**REGULAR MEETING OF THE PLANNING BOARD  
WEDNESDAY – JUNE 10, 2015  
7:30 PM  
CITY COMMISSION ROOM  
151 MARTIN STREET, BIRMINGHAM**

**CITY OF BIRMINGHAM  
PLANNING BOARD ACTION ITEMS  
OF WEDNESDAY, MAY 13, 2015**

**CITY OF BIRMINGHAM  
PLANNING BOARD ACTION ITEMS  
OF WEDNESDAY, MAY 27, 2015**

REFLECTED CEILING  
PLAN AND CANOPY  
SECTION

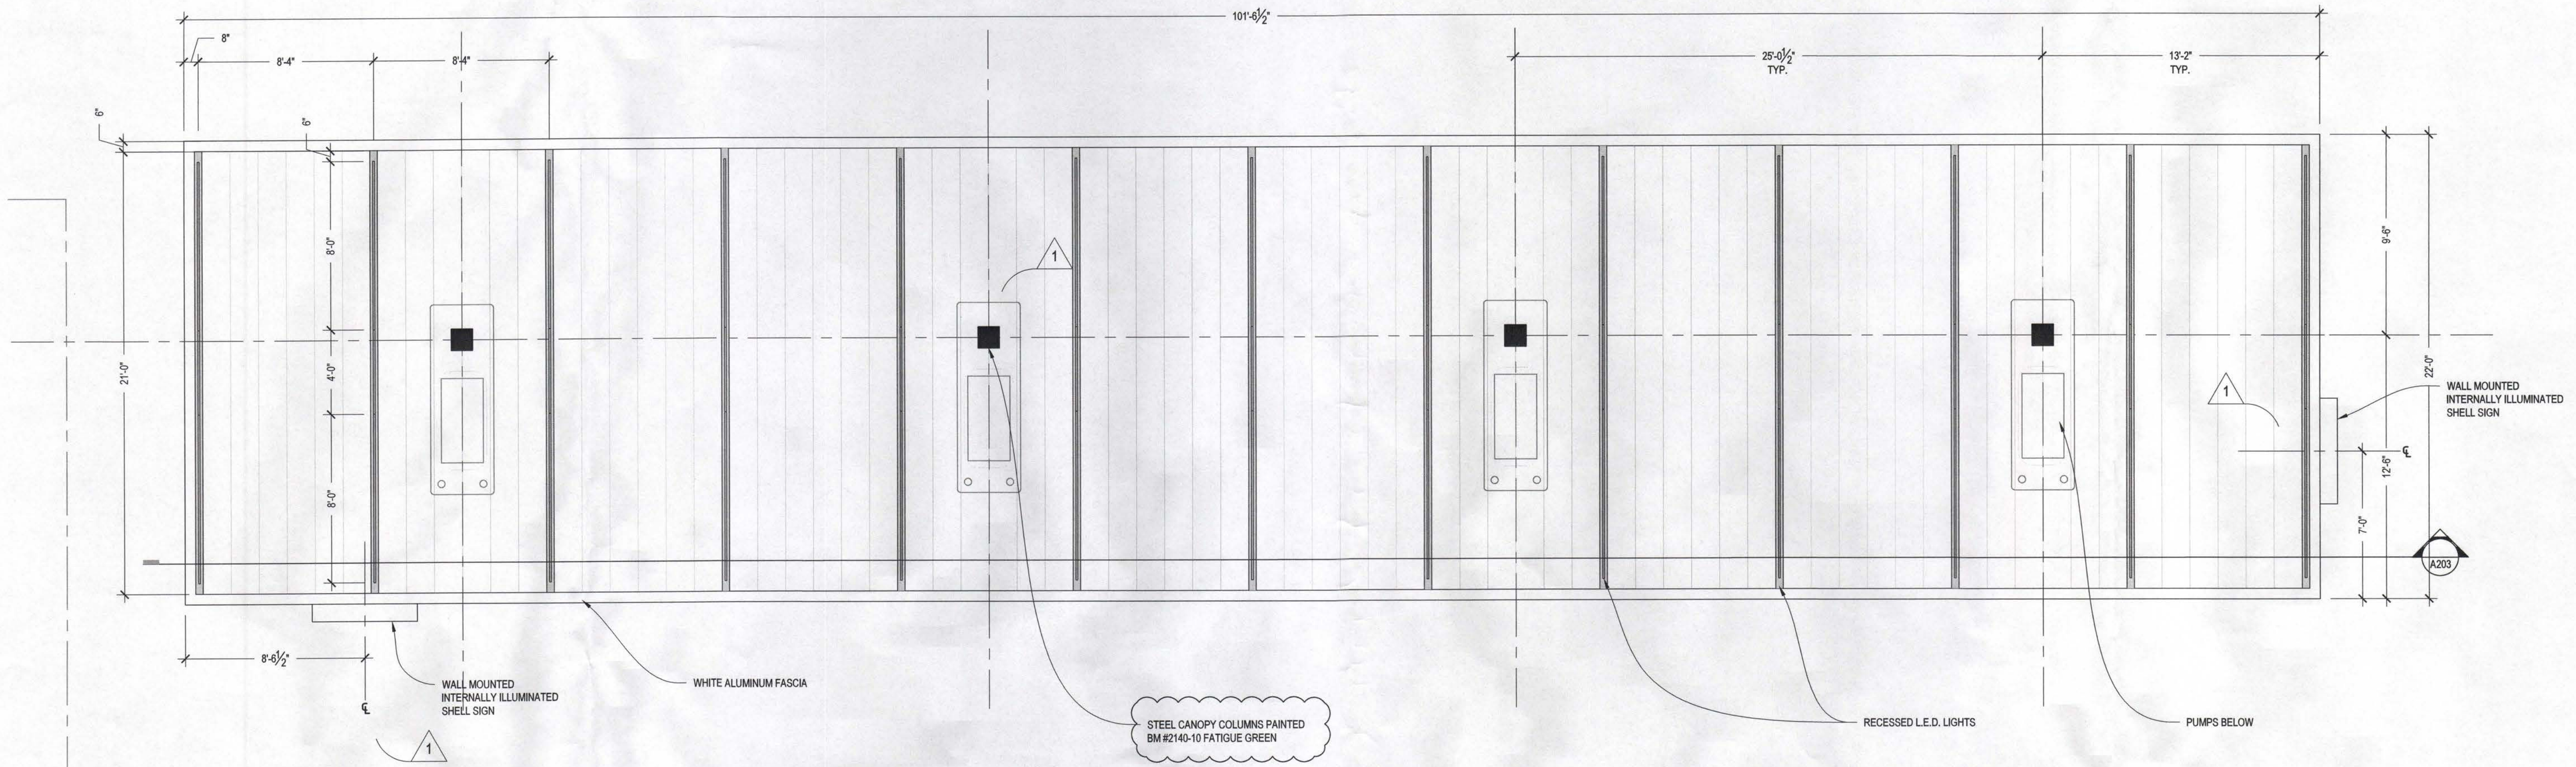
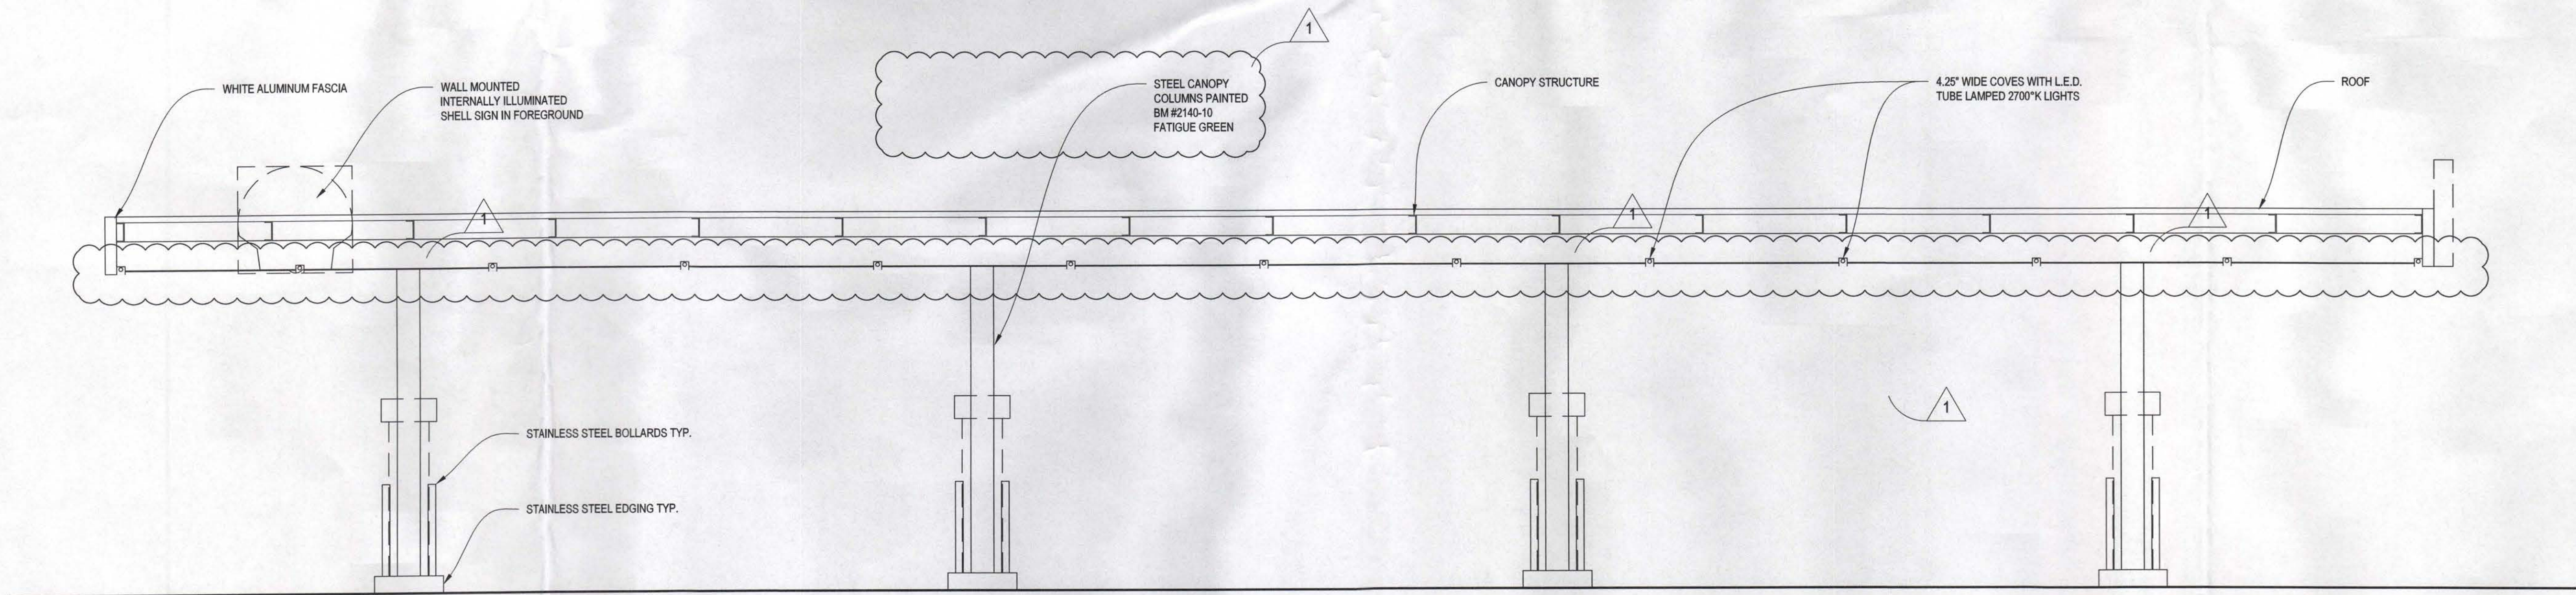
Ø Mr. Baka advised the Shell Gas Station (formerly known as Citgo) has asked to remove a 6 ft. screenwall between two parking areas on the southern boundary; change the underside of the canopy from Azak to a different material; paint the columns of the canopy rather than cladding them in Azak; change the body of the building from black to green. The board determined these are lower quality changes and the applicant should come back to the board for a full design review.
